## ETIHAD STADIUM NORTH STAND EXPANSION

### Addendum to Stage 3 Part 2 Construction Hoarding – crowd movement assessment

Following receipt of 12588700 Addendum to MCFC Construction Hoarding Impact Assessment Stage 3 Part 2 Crowd Modelling\_DRAFT.pdf and comments-12588700 Addendum to MCFC Construction Hoarding Impact Assessment Stage 3 Part 2 Crowd Modelling\_DRAFT.pdf please find below my comments.

**Crowd Risk Analysis Ltd (CRA) notes on 12588700 Addendum to MCFC Construction Hoarding Impact Assessment Stage 3 Part 2 Crowd Modelling\_DRAFT.pdf.**

Phase 1 construction hoarding layout (Source: Sisk)

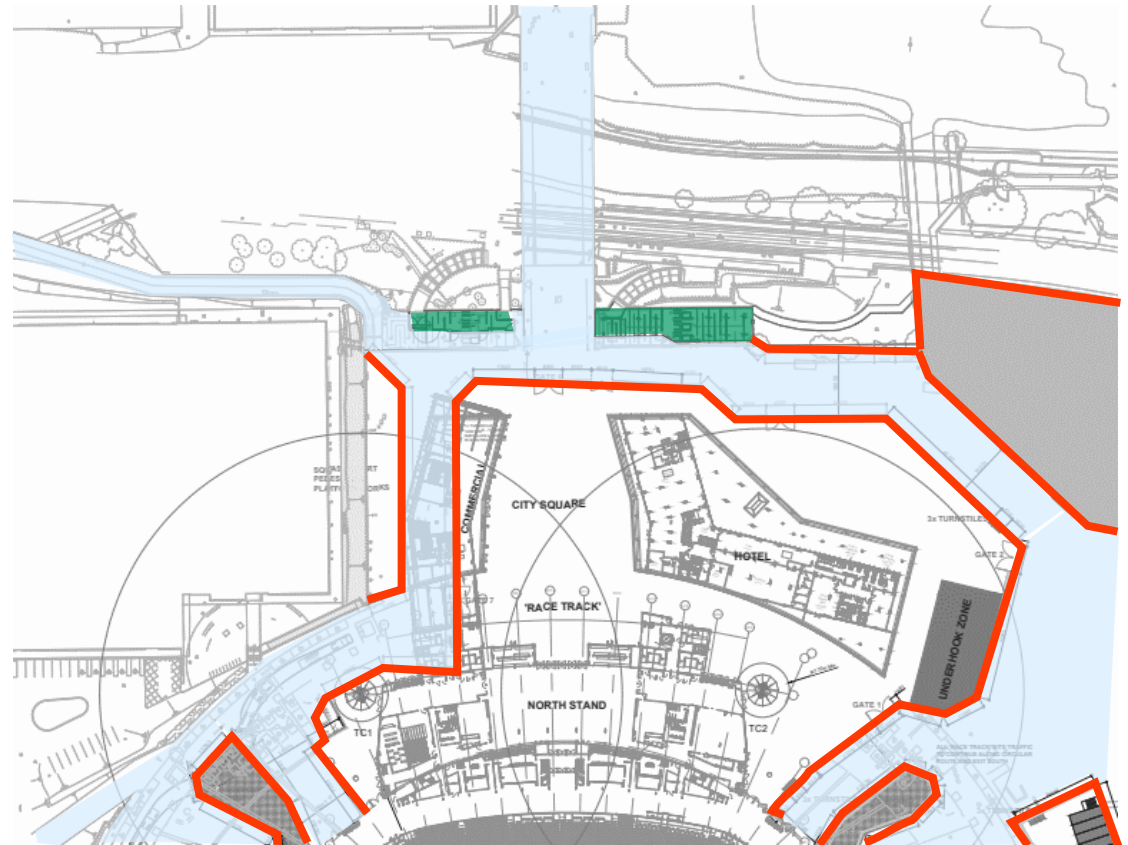
Page 6, the routes are smoother (less turbulence in crowd flow) other than the area shown below (purple oval). One caveat is that during previous projects at this site (and others) the hoarding is typically around plant/machinery, and not precision engineering. Indicative corridors (must be a minimum of X wide in this area) can be effective during construction.

| Item | Ref (page:title) | Category              | Reviewer Comment [paraphrased]                                                                                                                           | Response                                                                                                                                                                                                                                                                                                                                                                                                                                                                                                                                                                                                                                                                                                                                                                                                                                                                                                       | Proposed Action                                                                                                                                                                                                                                     | Outcome following discussion with the Reviewer | Status |
|------|------------------|-----------------------|----------------------------------------------------------------------------------------------------------------------------------------------------------|----------------------------------------------------------------------------------------------------------------------------------------------------------------------------------------------------------------------------------------------------------------------------------------------------------------------------------------------------------------------------------------------------------------------------------------------------------------------------------------------------------------------------------------------------------------------------------------------------------------------------------------------------------------------------------------------------------------------------------------------------------------------------------------------------------------------------------------------------------------------------------------------------------------|-----------------------------------------------------------------------------------------------------------------------------------------------------------------------------------------------------------------------------------------------------|------------------------------------------------|--------|
| 3    | 1: Page 6        | As built layout       | Hoarding layout around plant/machinery is unlikely to be as precise as shown. Indicative corridor minimum widths would be useful for the contractor.     | <b>[See Response 01 for more detail]</b><br>Agreed. Simplified diagrams with minimum widths assumed for modelling are provided.                                                                                                                                                                                                                                                                                                                                                                                                                                                                                                                                                                                                                                                                                                                                                                                | Sisk / MCFC Operations Team to identify and inform of changes to the minimum widths provided.                                                                                                                                                       |                                                | Open   |

Phase 2 construction hoarding layout (Source: Sisk)

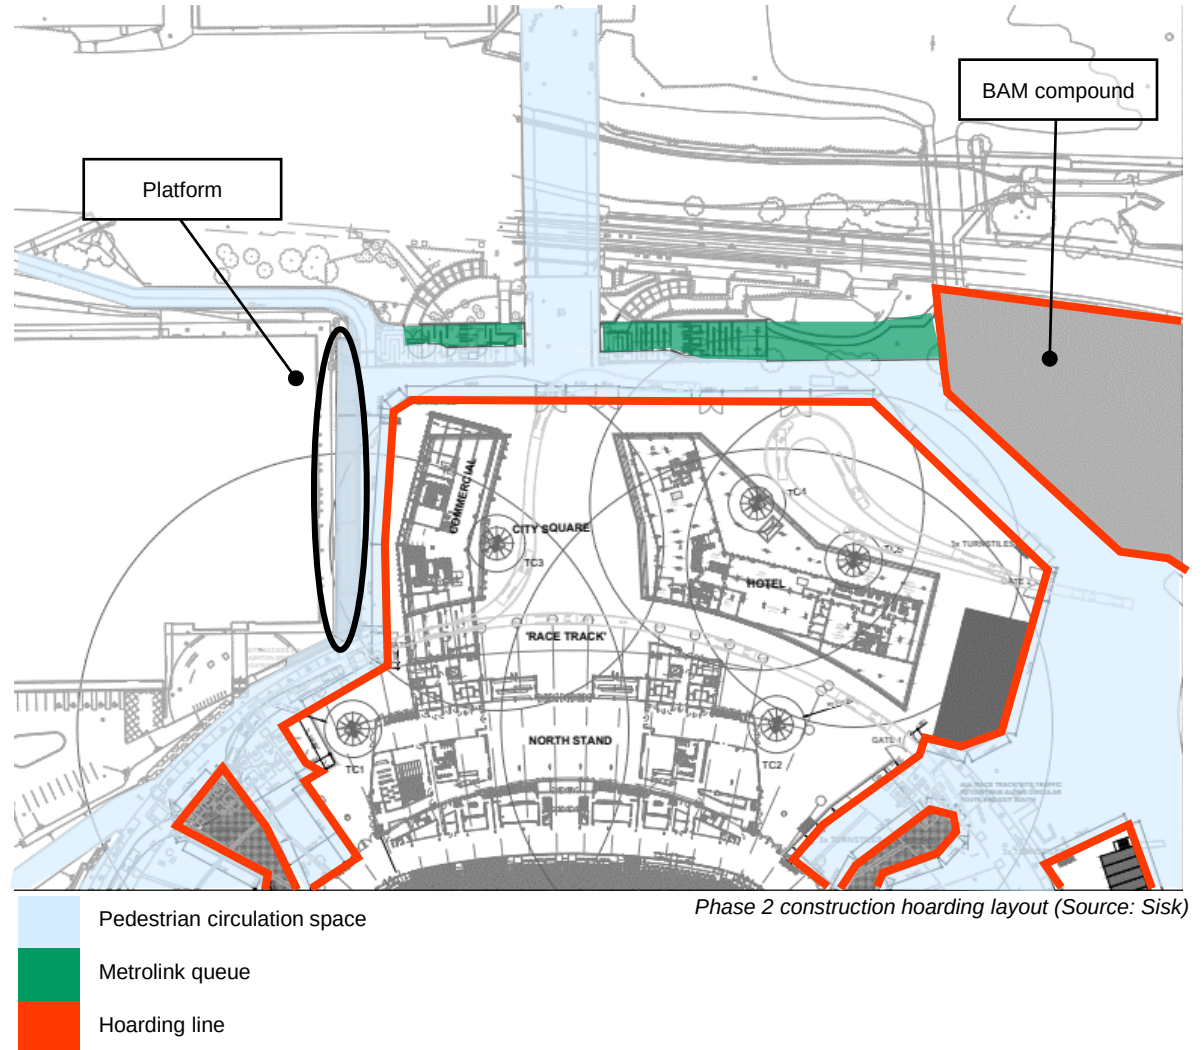
Page 7, the diagram below shows a couple of “kinks” in the hoarding. When presenting these to the construction team (for build) it may not fit the material. For example, if the hoarding is in 3-4m lengths. As above, indicative corridors” of a minimum width may be more useful for the construction phase. Similar on page 8.

| Item | Ref (page:title) | Category              | Reviewer Comment [paraphrased]                                                                                                                           | Response                                                                                                                                                                                                                                                                                                                                                                                                                                                                                                                                                                                                                                                                                                                                                                                                                                                                                                       | Proposed Action                                                                                                                                                                                                                                     | Outcome following discussion with the Reviewer | Status |
|------|------------------|-----------------------|----------------------------------------------------------------------------------------------------------------------------------------------------------|----------------------------------------------------------------------------------------------------------------------------------------------------------------------------------------------------------------------------------------------------------------------------------------------------------------------------------------------------------------------------------------------------------------------------------------------------------------------------------------------------------------------------------------------------------------------------------------------------------------------------------------------------------------------------------------------------------------------------------------------------------------------------------------------------------------------------------------------------------------------------------------------------------------|-----------------------------------------------------------------------------------------------------------------------------------------------------------------------------------------------------------------------------------------------------|------------------------------------------------|--------|
| 4    | 2: Page 7        | As built layout       | Hoarding layout around plant/machinery is unlikely to be as precise as shown. Indicative corridor minimum widths would be useful for the contractor.     | See response for Item 3                                                                                                                                                                                                                                                                                                                                                                                                                                                                                                                                                                                                                                                                                                                                                                                                                                                                                        | See response for Item 3                                                                                                                                                                                                                             |                                                | Open   |

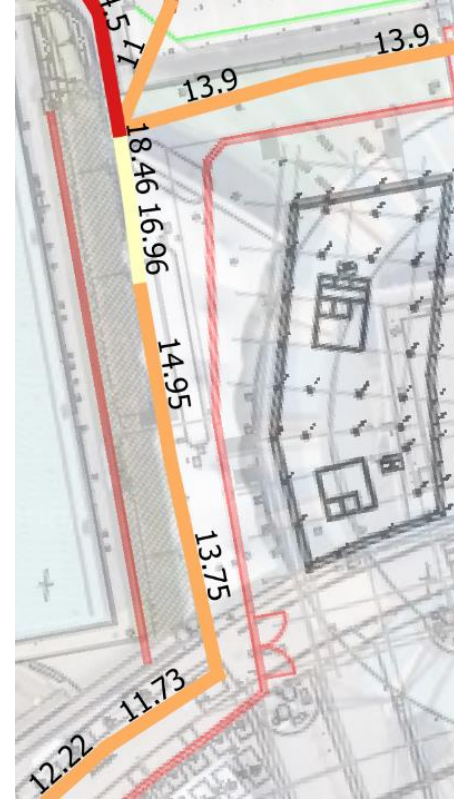
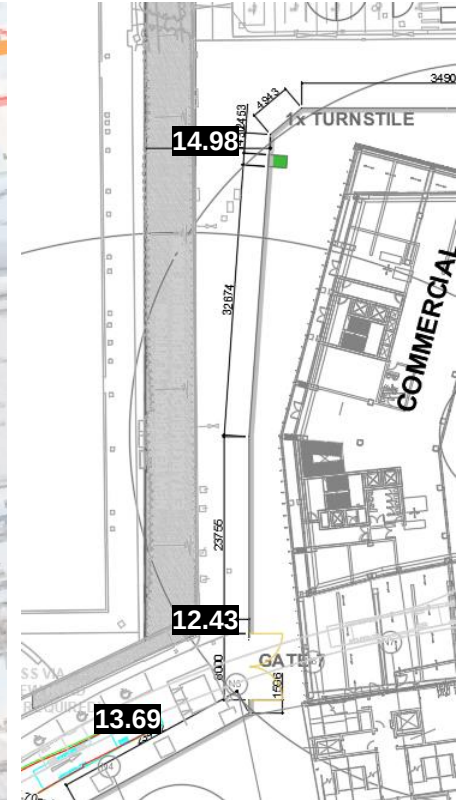
*The pedestrian route to the west of the construction compound (by the Squash Court) was identified as a route where the target capacity was exceeded, and queues would form. The adjacent image shows the changed to the hoarding layout proposed by Sisk.*

This highlights the smoother routes (as planned) which should be emphasis as “as built” and recommended minimum widths within the bounds of construction materials, as indicated above.

| Item | Ref (page:title) | Category              | Reviewer Comment [paraphrased]                                                                                                                       | Response                                                                                                                                                                         | Proposed Action                                                                                                                                                                                                                                                                         | Outcome following discussion with the Reviewer | Status |
|------|------------------|-----------------------|------------------------------------------------------------------------------------------------------------------------------------------------------|----------------------------------------------------------------------------------------------------------------------------------------------------------------------------------|-----------------------------------------------------------------------------------------------------------------------------------------------------------------------------------------------------------------------------------------------------------------------------------------|------------------------------------------------|--------|
| 6    | 4: Page 12       | As built layout       | Hoarding layout around plant/machinery is unlikely to be as precise as shown. Indicative corridor minimum widths would be useful for the contractor. | See response for Item 3                                                                                                                                                          | See response for Item 3                                                                                                                                                                                                                                                                 |                                                | Open   |

#### North Stand and Arena Max Queue by Link

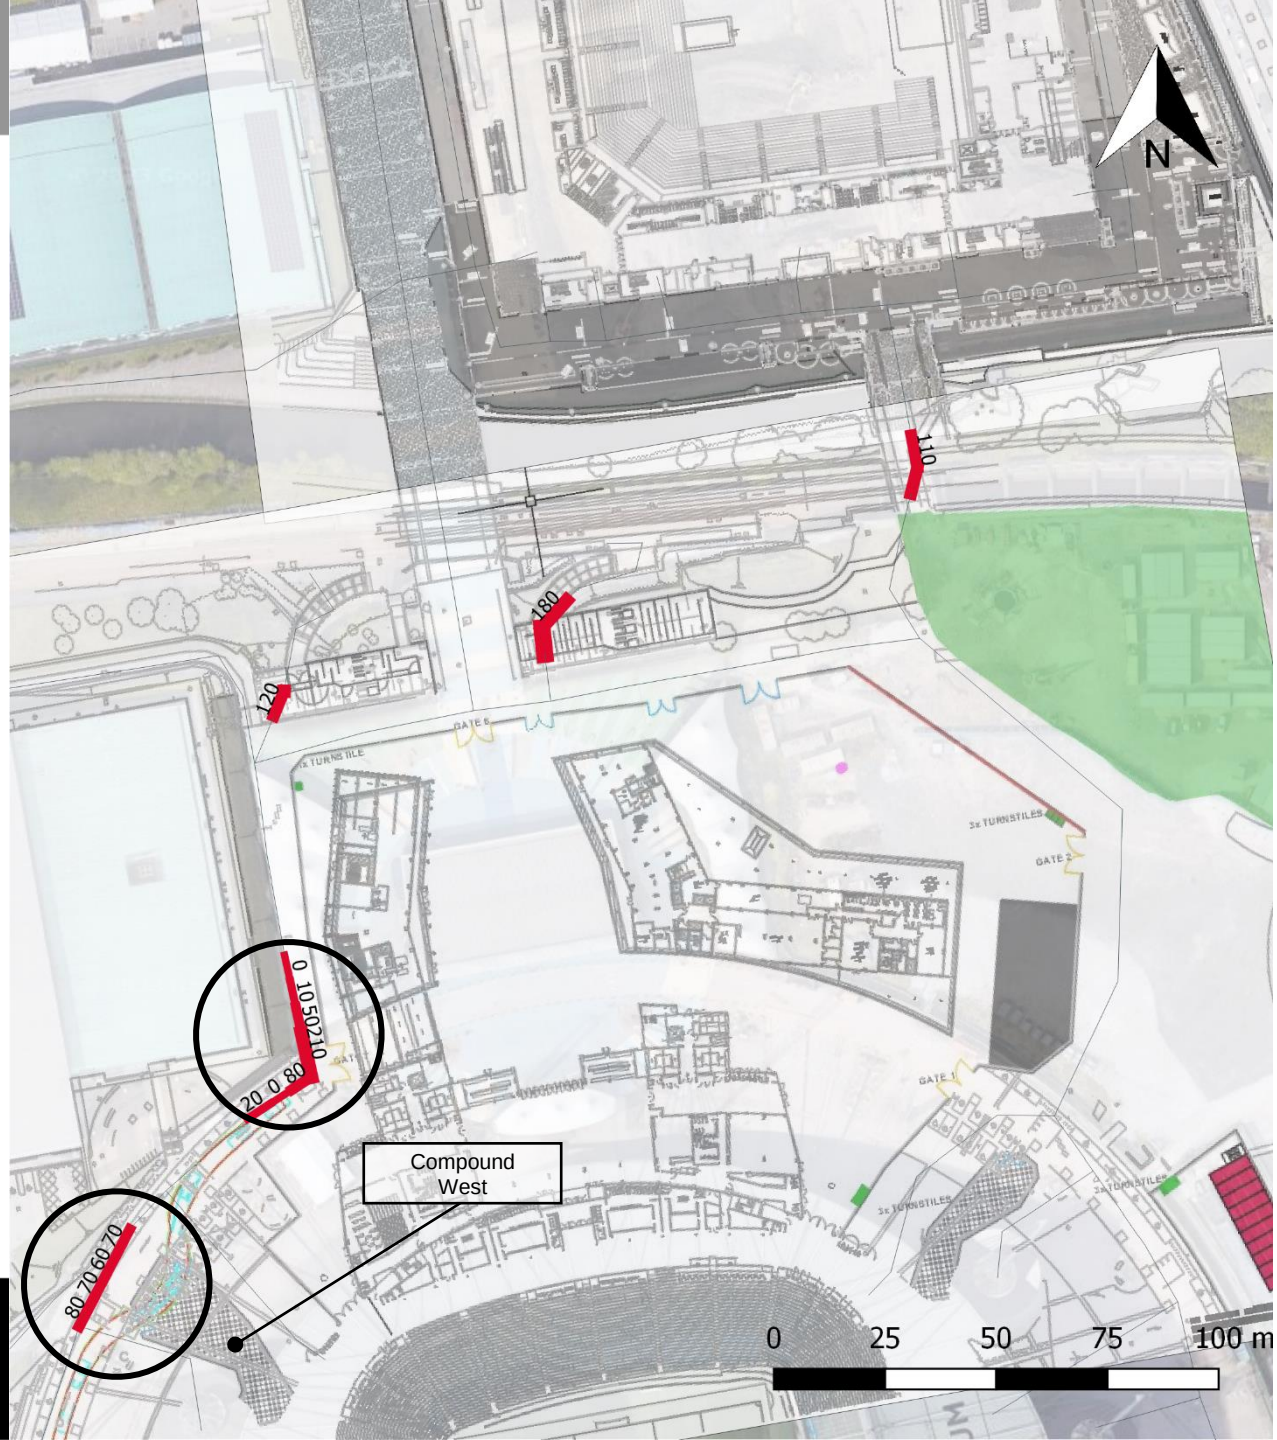
Page 16, highlights the density and duration of the queueing patrons.

Upstream hold and release could alleviate/regulate the crowd flow, but in an emergency evacuation, that option is not viable for rapid egress. I would suggest that an extreme scenario is assessed for impact/risk of crowd density. I also stress that the SENSE model (and most simulations) all assume no trips, slips, falls in these areas.

| Item | Ref (page:title) | Category              | Reviewer Comment [paraphrased]                                                                                                                       | Response                                                                                                                                                                         | Proposed Action                                                                                                                                                                                                                                                                         | Outcome following discussion with the Reviewer | Status |
|------|------------------|-----------------------|------------------------------------------------------------------------------------------------------------------------------------------------------|----------------------------------------------------------------------------------------------------------------------------------------------------------------------------------|-----------------------------------------------------------------------------------------------------------------------------------------------------------------------------------------------------------------------------------------------------------------------------------------|------------------------------------------------|--------|
| 8    | 4: Page 16       | Operations            | The Stadium + Arena simultaneous egress scenario indicates management will be required on the route by Squash Centre)                                | <p>Agreed.</p> <p>Please refer to Table Item 5 in '23Jun08 MCFC NS_MS_CRA notes on Construction Hoarding_DRAFT.docx'</p> <p>Arena expected to be in operation in April 2024.</p> | <p>The 'Stadium + Arena simultaneous egress' scenario will require monitoring of potential changes to Etihad Stadium travel patterns and development of a 'reasonable worst case' scenario.</p> <p>Parameters of Reviewer's proposed new 'extreme scenario' to be discussed/agreed.</p> |                                                | Open   |

Item 8. Open – extreme and worse case to be discussed and agreed. This is an ongoing risk analysis and desktop exercise for operational review
